MOORE SUBDIVISION

Engineering Comments: FINAL PLAT COMMENTS (should be addressed prior to submitting the FINAL PLAT for review and/or signature by the City Engineer):

DETAIL SITE PLAN

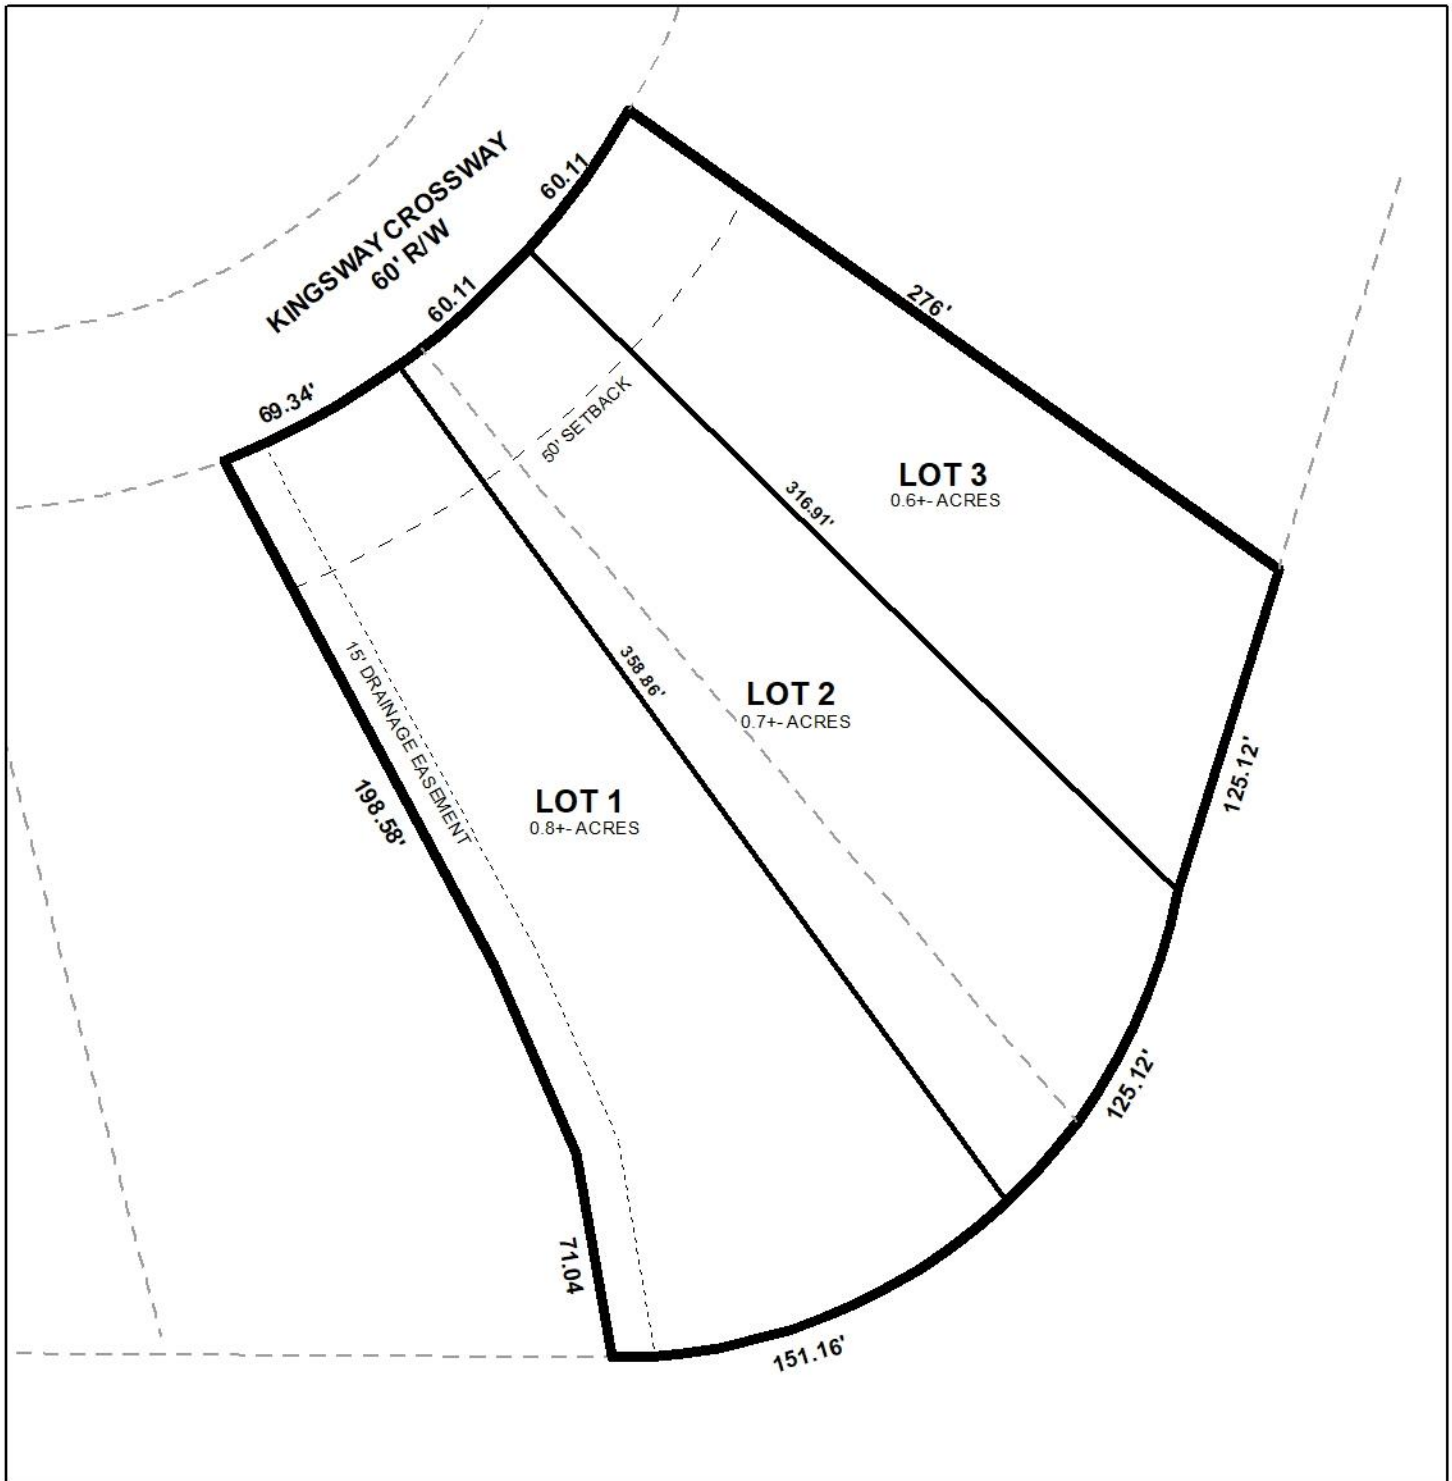
The preliminary plat indicates that all proposed lots meet the minimum size requirements of the Subdivision Regulations. As on the preliminary plat, the lot size labels in both square feet and acres should be retained on the Final Plat, or a table should be furnished on the Final Plat providing the same information.

All three lots exceed the width-to-depth ratio of Section V.D.3. of the Subdivision Regulations. It is the practice of the Planning Commission to waive Section V.D.3. of the Subdivision Regulations when there are other lots in the area that exceed the width-to-depth ratio; however, it appears there are no other lots which exceed the width-to-depth ratio in the area, and no justification was provided by the applicant for the narrow lot configuration.

The lots have frontage along Kingsway Crossway, a minor street without curbs and gutters and a compliant 60' right-of-way; therefore, no dedication would be required. The right-of-way width of Kingsway Crossway should be retained on the Final Plat, if approved.

There is a 50-foot minimum building setback line depicted across the proposed lots, which exceeds the minimum setback of 25-feet required by Section V.D.9. of the Zoning Ordinance. If approved, the front setback should be retained on the Final Plat.

The plat indicates a drainage easement on the proposed Lot 1. Therefore, a note should be required on the Final Plat stating that no structures shall be constructed or placed within any easement without permission of the easement holder.

Finally, there is an existing structure on the site that appears to cross lot lines. This is allowable, assuming that the setbacks created by the subdivision's approval are compliant with Zoning Ordinance requirements. Therefore, if approved, either demolition permits for the existing dwelling should be obtained prior to the signing of the Final Plat, or the Final Plat should be revised to depict the dwelling with compliant setbacks.

Based on the preceding, this application is recommended for Denial due to the following:

- 1) The proposed lots exceed the maximum width-to-depth ratio of Section V.D.3. of the Subdivision Regulations.
